# **87C196KR SPECIFICATION UPDATE**

Release Date: December, 1998

Order Number: 272861-004

The 87C196KR may contain design defects or errors known as errata. Characterized errata that may cause the 87C196KR's behavior to deviate from published specifications are documented in this specification update.

Figure 1. 16-bit System with EPROM

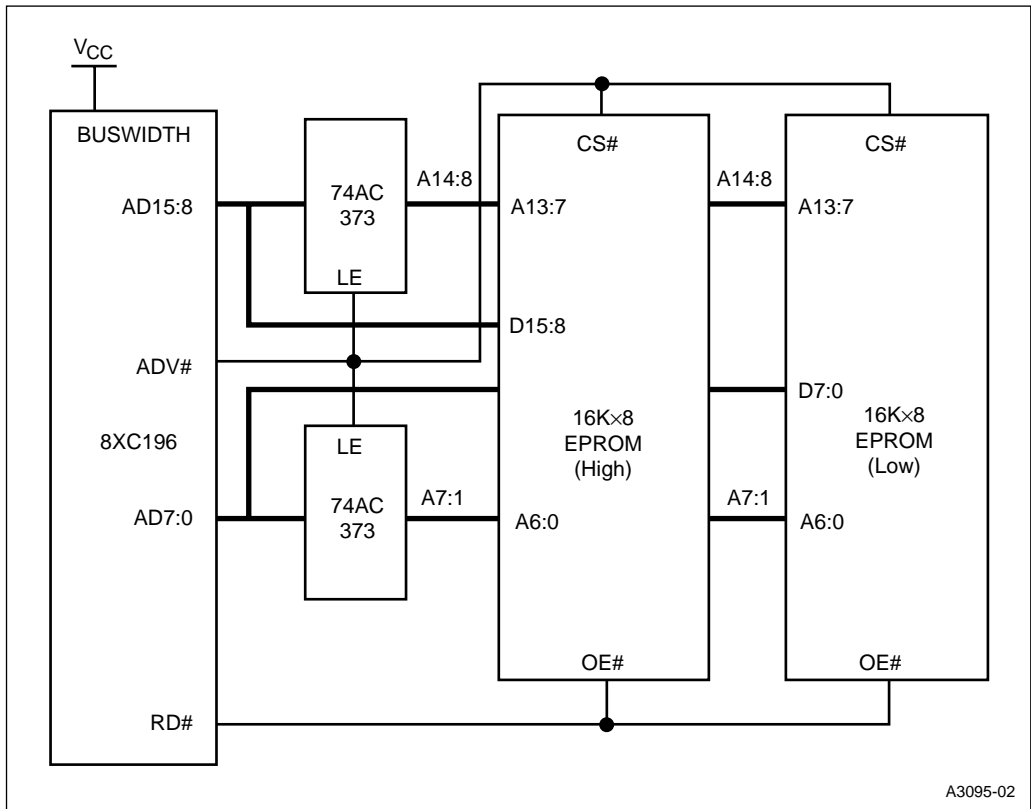
1. **High Address Inputs to the Low EPROM Should be A14:8 in Figure 15-18.**

**ITEM:** The next revision of the user’s manual will include the following corrected graphic.
